CALIFORNIA COASTAL COMMISSION

SUBJECT: Revised Findings for UCSB Long Range Development Plan (LRDP) Amendment 1-04 and Notice of Impending Development (NOID) 2-04, for the San Clemente Housing Project, for Public Hearing and Commission Action at the September 2005, Commission Meeting in Eureka.

COMMISSION DECISION: STB-MAJ-1-04 Certified with Suggested Modifications; NOID 2-04 Approved with Conditions

Exhibit 4a
UCSB LRDP 1-04 & NOID 2-04
Certified Land Use & Circulation

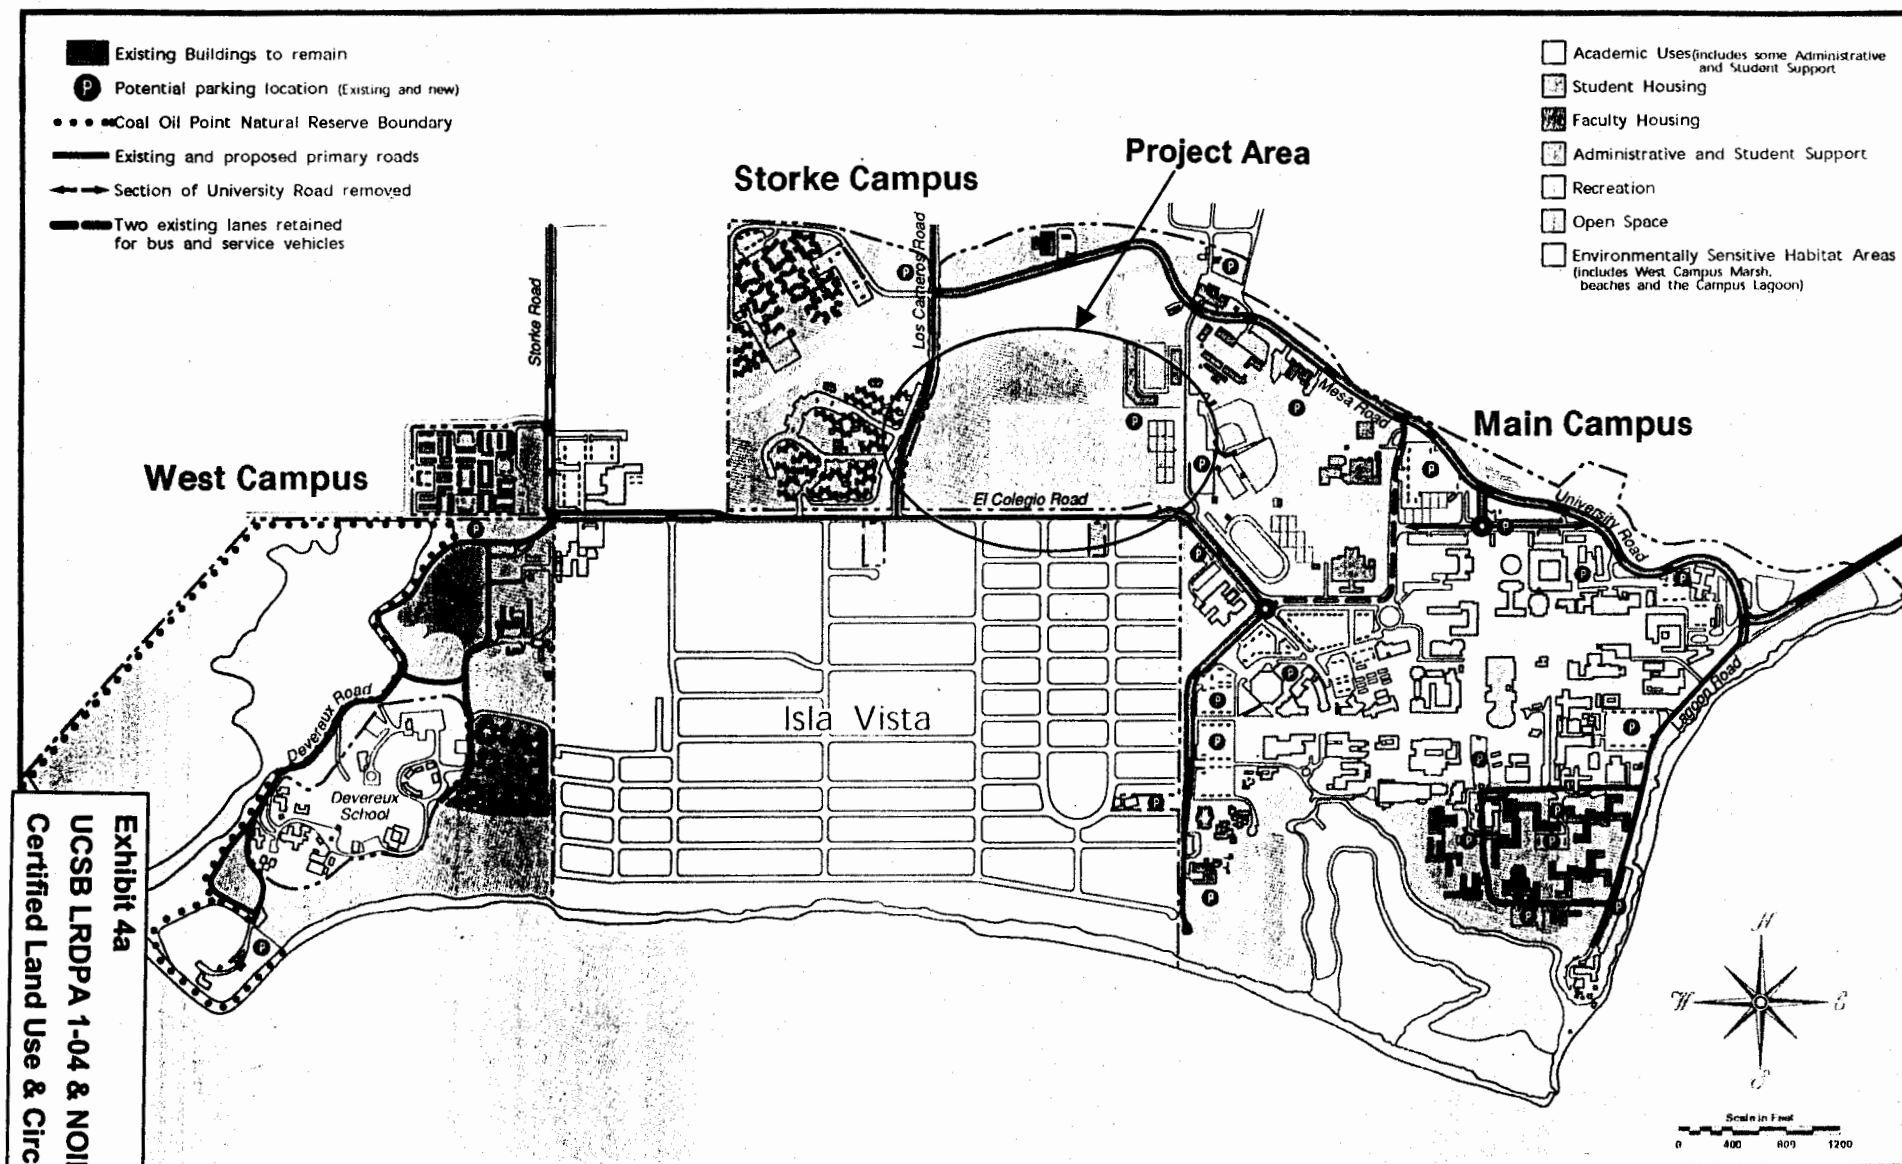
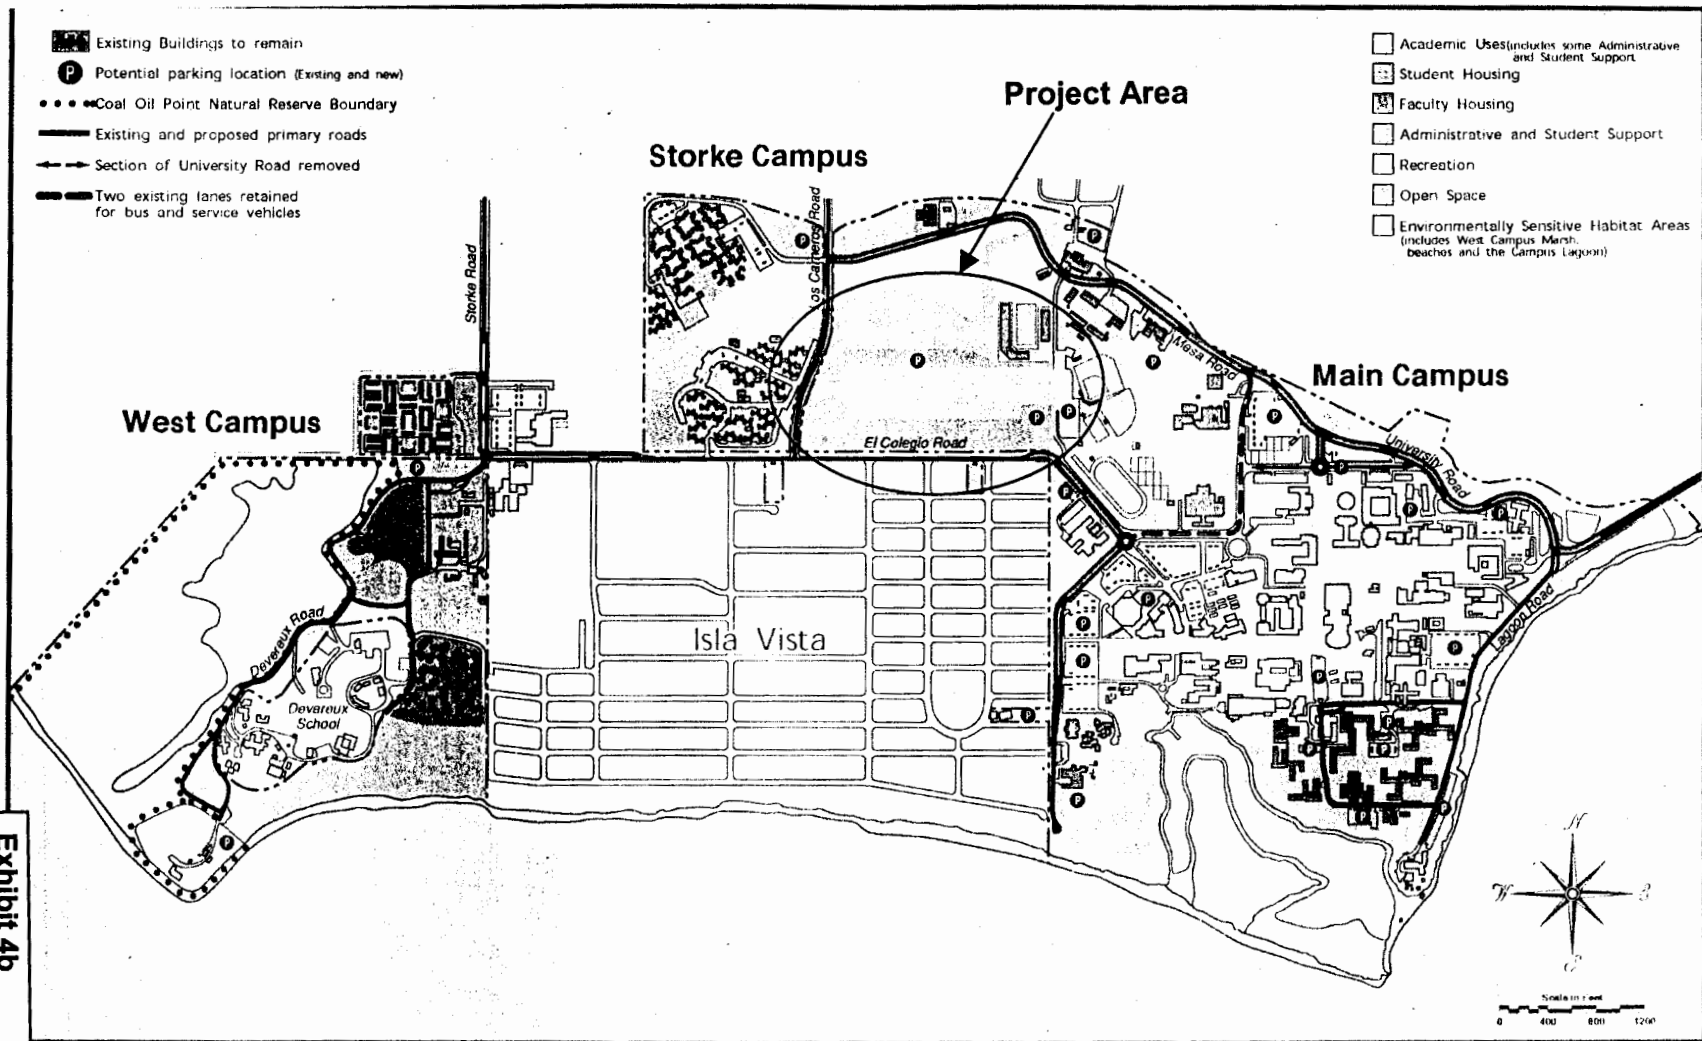
Figure 10 Land Use and Circulation, Figure 16 Campus Building Height Limits, and Figure 23 Storke Campus Plan of the certified Long Range Development Plan shall retain the certified land use designation (housing) and associated height limit in the area of the proposed athletic field north of Parking Lot #38.

Specifically, the proposed amendment modifies Figure 10 *Land Use and Circulation* (Exhibit 4), Figure 16 *Campus Building Height Limits* (Exhibit 5), and Figure 23 *Storke Campus Plan* (Exhibit 6) of the certified Long Range Development Plan to reflect the revised configuration of the housing site and design of the San Clemente Housing Project. Additionally, the amendment makes text amendments to all references within the 1990 LRDP regarding the number of residential units and bed spaces. The certified LRDP indicates that the student housing site adjacent to Storke Field may provide up to 281 residential units and contain 900 bed spaces. All such references shall be modified to represent the 315-unit and 976-bed space project proposed.

Exhibit 5a
LRDPA 1-04 & NOID 2-04
Certified Height Limit

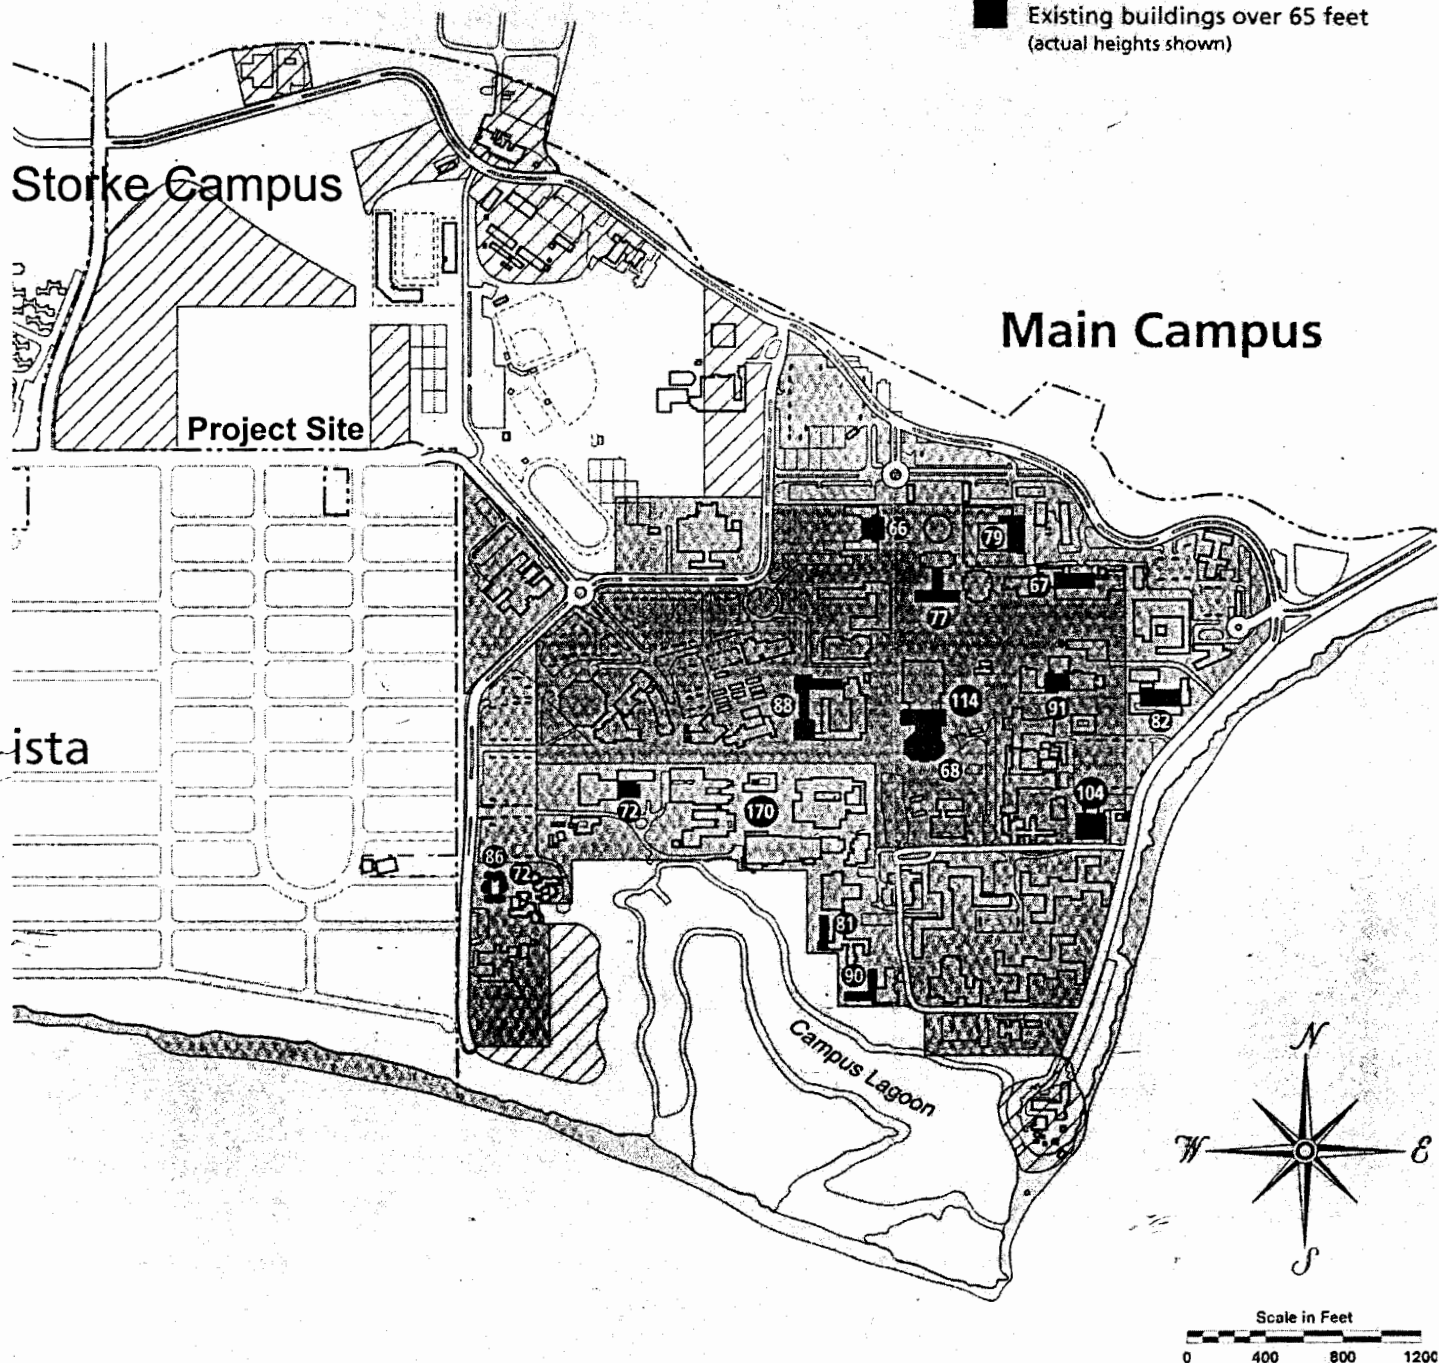
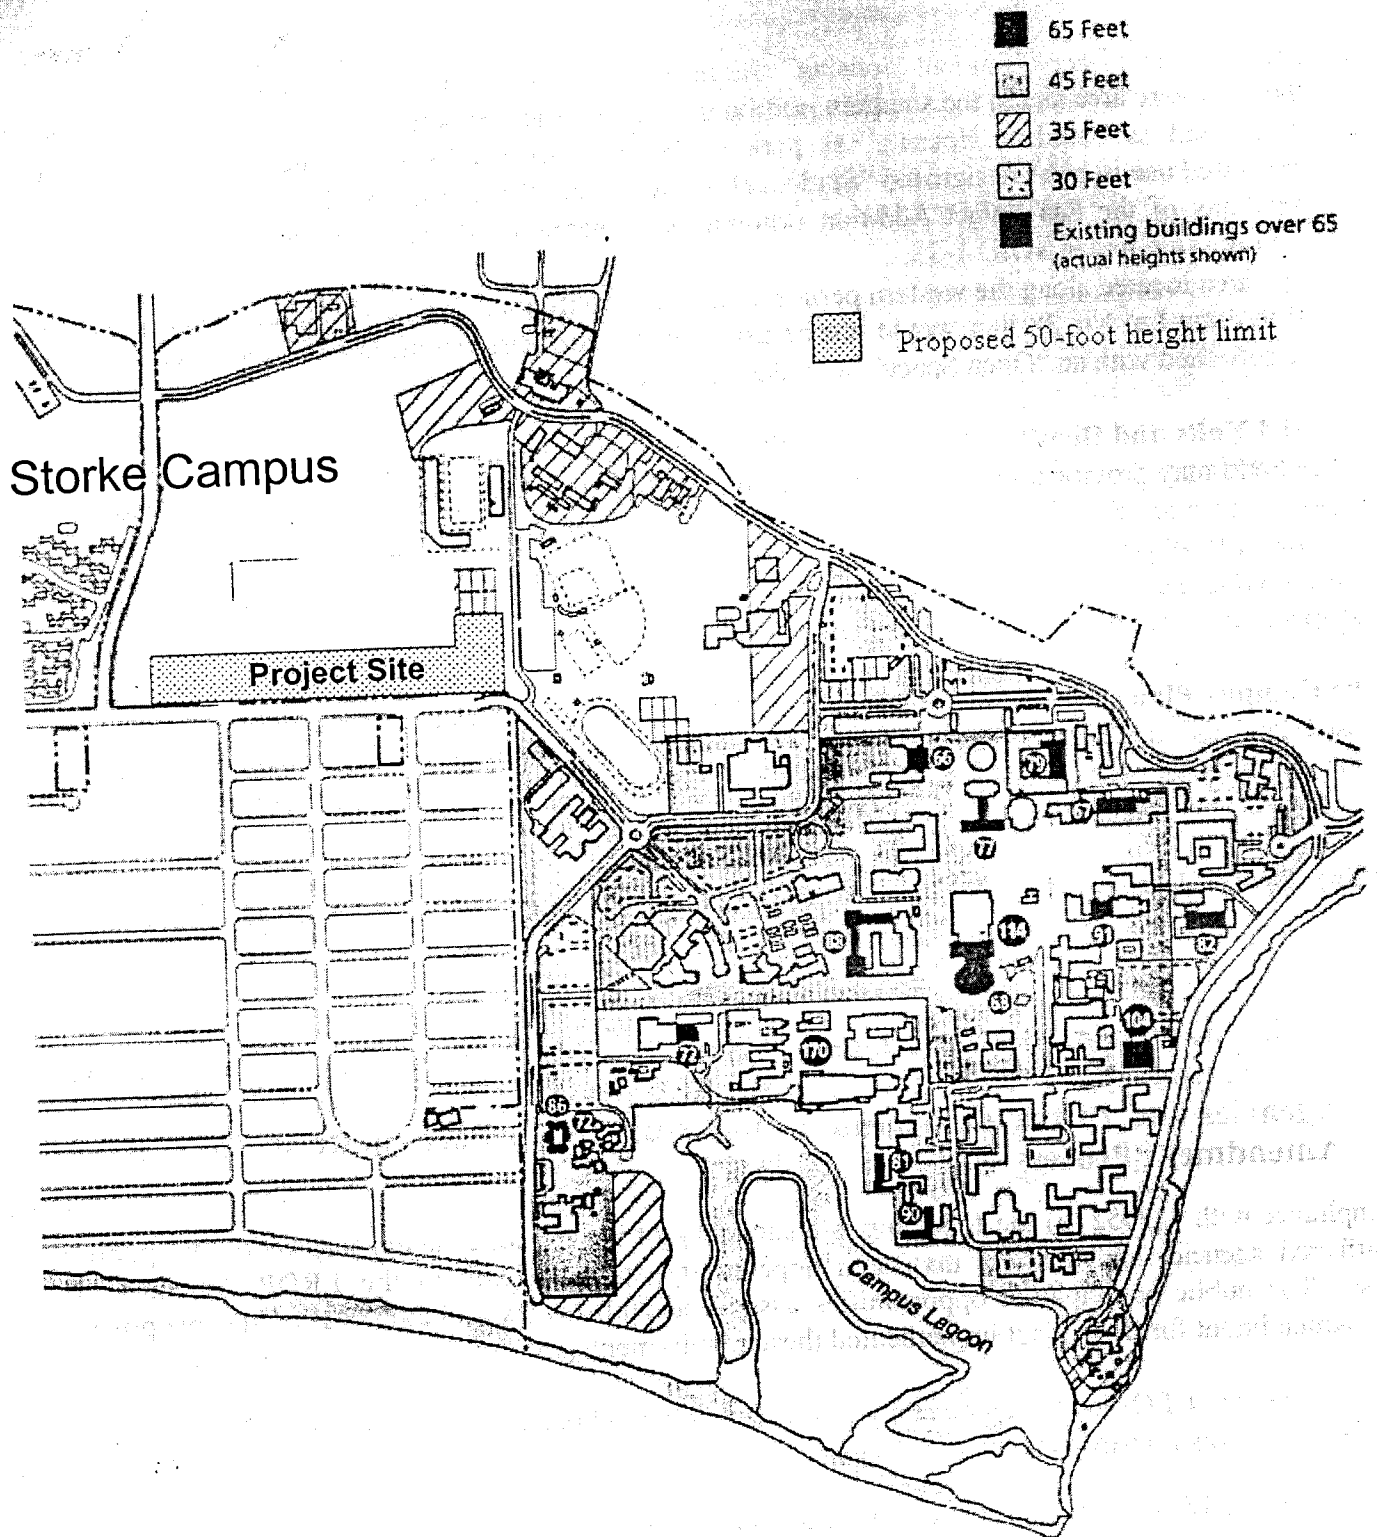
Figure 16, *Campus Building Height Limits*, shall be modified to show a maximum building height of 35-45 feet above existing grade, in the location of the housing development as shown in Exhibit 7 of this staff report. The exhibit shall specify that structures adjacent to El Colegio shall not exceed 35 feet above existing grade. The height may gradually increase to a maximum of 45 feet above existing grade as it approaches Storke Field. Parking structures shall not exceed 35 feet in height.

Therefore to ensure consistency with the surrounding character to the maximum extent feasible pursuant to Section 30251 of the Coastal Act, the Commission requires **Suggested Modification Two (2)** to revise Figure 16 of the LRDP to designate a maximum building height of 35-45 feet in the location of the housing development as shown in Exhibit 7 of this staff report. The Commission finds that a height limitation of 35-45 feet above existing grade for development at the new housing site is necessary to ensure compatibility with the surrounding environment and existing development. As further detailed in **Suggested Modification Three (3)**, this height limit will be a graduated increase from a maximum of 35 feet at El Colegio Road and gradually increasing to a maximum of 45 feet above existing grade as the development approaches Storke Field. Maximum heights as calculated in the LRDP do not include the additional height of mechanical or electrical equipment placed on the rooftops of the buildings. The elevator overrun would therefore not be calculated as part of the total maximum height of the parking structure. Suggested Modification 3 adds additional policy language to set back the mechanical and electrical equipment as far as feasible from El Colegio Road, and to camouflage equipment behind screening or other architectural features.
